Addendum #1

Project: Park Manor Public School – Phase 2, 18 Mockingbird Dr, Elmira, ON N3B 1T1
Project No.: 21970
Date: 25 February, 2022

PROJECT:
Park Manor Public School - Phase 2 Interior and Window Enhancements

DRAWING NO:
A201

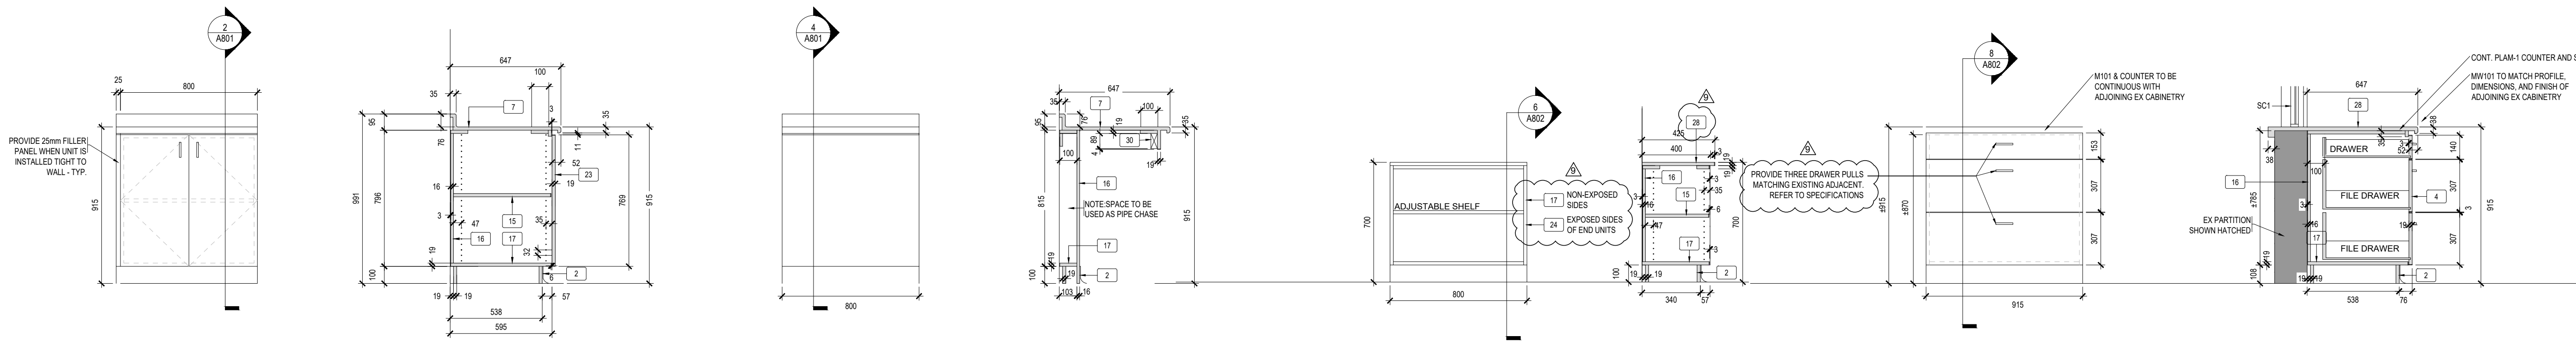
6. A201 PARTIAL GROUND FLOOR REFLECTED CEILING PLAN - PROPOSED (issued here within)
 1. **DELETE** the 2nd item in the RCP Legend “Ceiling Exhaust / Return Grille (refer to mechanical) in RCP Legend”.

2. **DELETE** the words “ceiling exhaust” in the 3rd item in the RCP Legend. This is only for return air grilles.
 3. **DELETE** all return air grilles shown on the RCP issued on Feb. 11th, 2022.

ADD return air grilles as shown in the attached RCP

4. **DELETE** lighting and supply air layout in Corridor NW1, N1 and N3 on the RCP issued on Feb. 11th, 2022.

ADD lighting and supply air layout in Corridor NW1, N1 and N3 to the attached RCP. Where possible, the lighting and supply air are revised to fit within the ceiling grid. The ceiling grid pattern is designed to be continuous throughout the corridors and do not shift.

A802

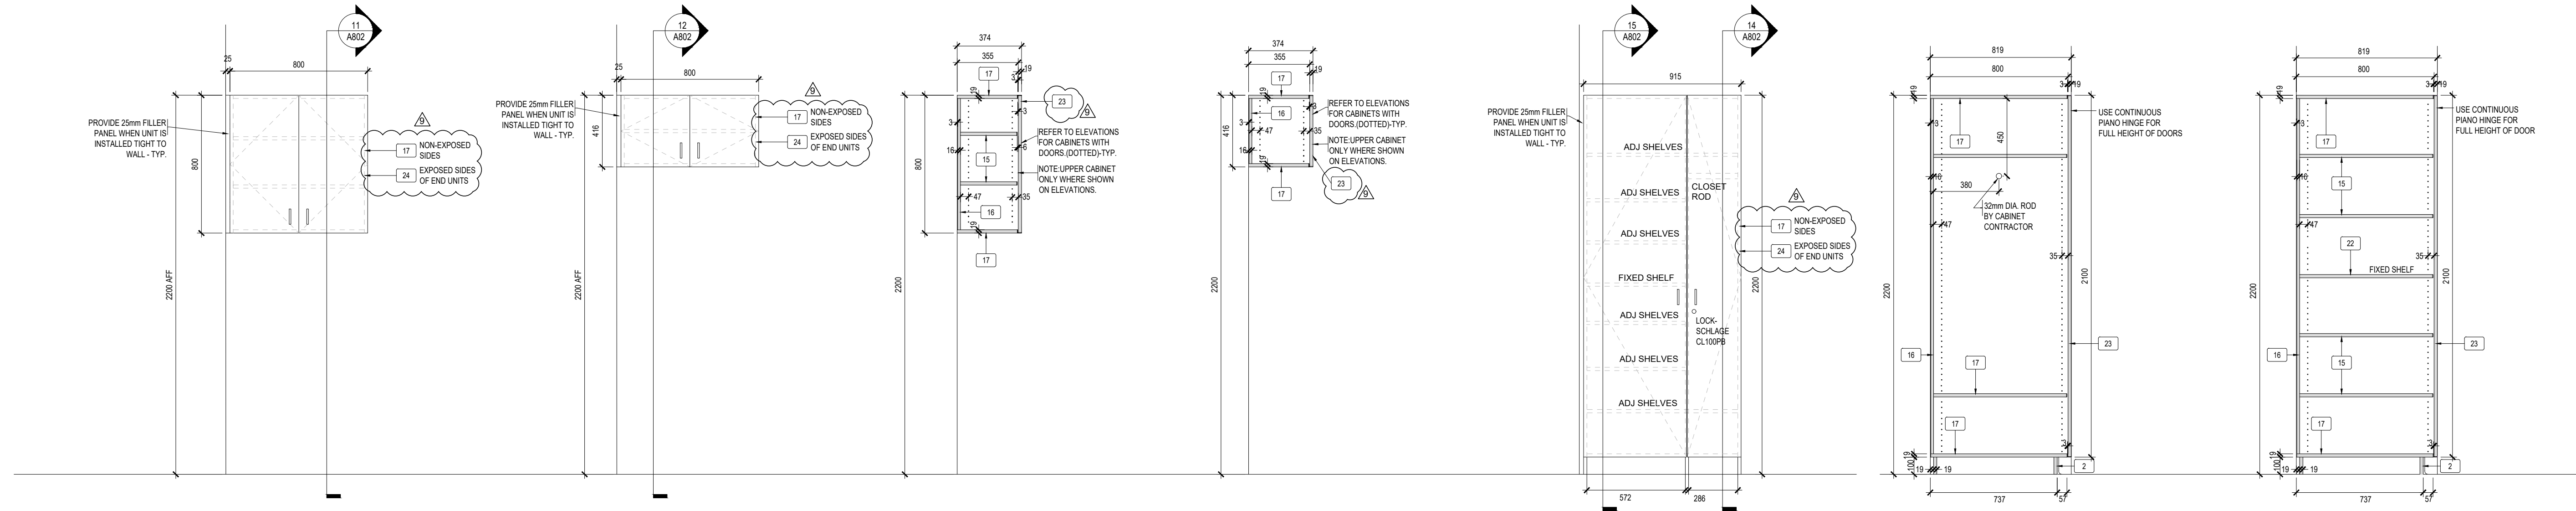
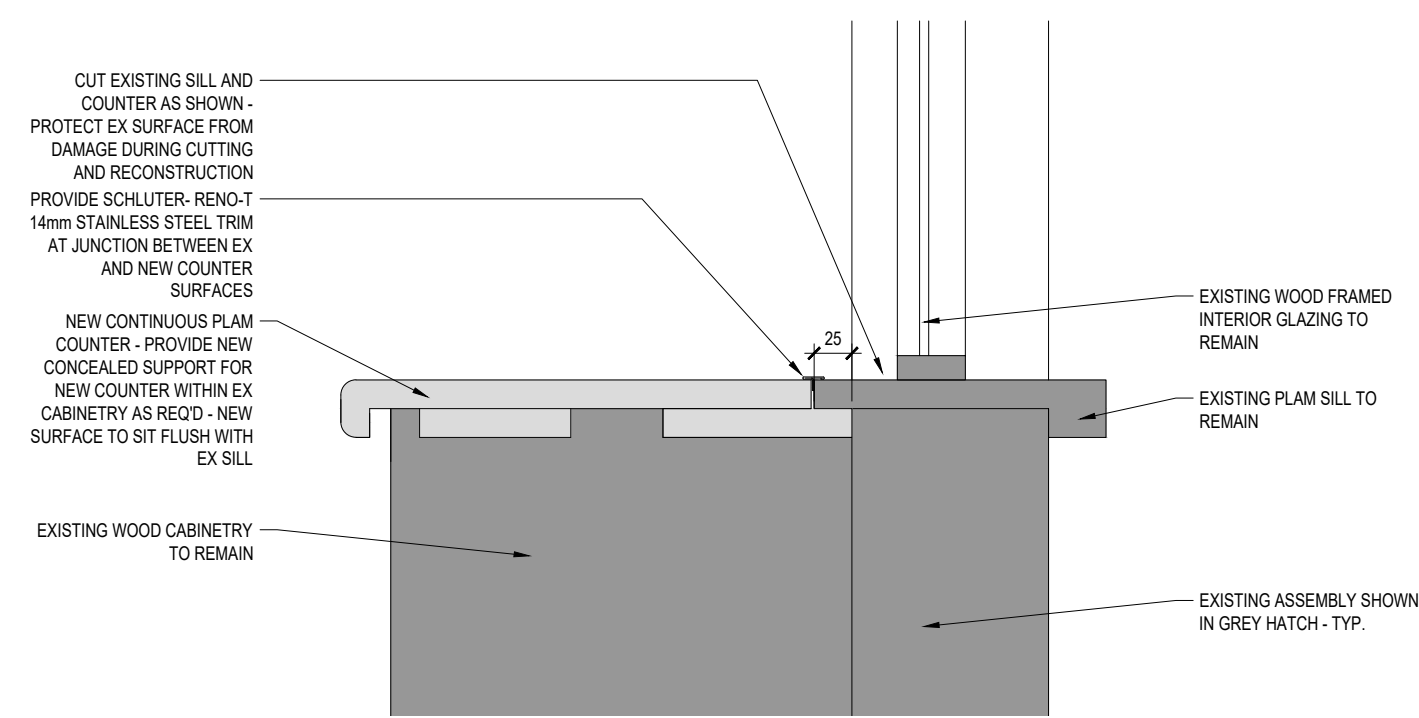
1. **DELETE** item "4. 19mm plastic laminate panel drawer front complete with PVC edges. Refer to spec for drawer sliders and drawer construction (metabox)" in Millwork Materials Legend issued on Feb. 11, 2022.

ADD item "4. 19mm wood veneer panel stained to match existing adjacent cabinets. Drawer front complete with PVC edges. Refer to spec for drawer sliders and drawer construction (metabox)" in Millwork Materials Legend as attached.

2. **DELETE** item "17. 19mm melamine top, bottom c/w 3mm PVC edge" in Millwork Materials Legend issued on Feb. 11, 2022.

3. **ADD** item "17. 19mm melamine top, bottom and gable c/w 3mm PVC edge. In Millwork Materials Legend issued at attached.
4. **DELETE** item "28. Plastic Laminate on 19mm plywood" in Millwork Materials Legend issued on Feb. 11, 2022.
ADD item "28. Plastic laminate countertop c/w 3mm PVC on all exposed edges" in Millwork Materials Legend as attached.

5. **ADD** legend item "17 Non-exposed sides" and "24 Exposed sides of end units" to indicate the material finish for the gables in drawing 5, 9, 10, 13 / A802. Refer to the attached drawing A802.

6. **DELETE** legend item "13" indicating the material finish of the countertop in drawing 6/A802 issued on Feb. 11th, 2022.
ADD legend item "28" to indicate the material finish of the countertop in drawing 6/A802 as attached.

7. **ADD** note "Provide three drawer pulls matching existing adjacent. Refer to specifications" to drawing 7/A802 as attached.
8. **ADD** legend item "23" to indicate the material finish for the doors of the upper cabinets in drawing 11, 12 / A802 as attached.
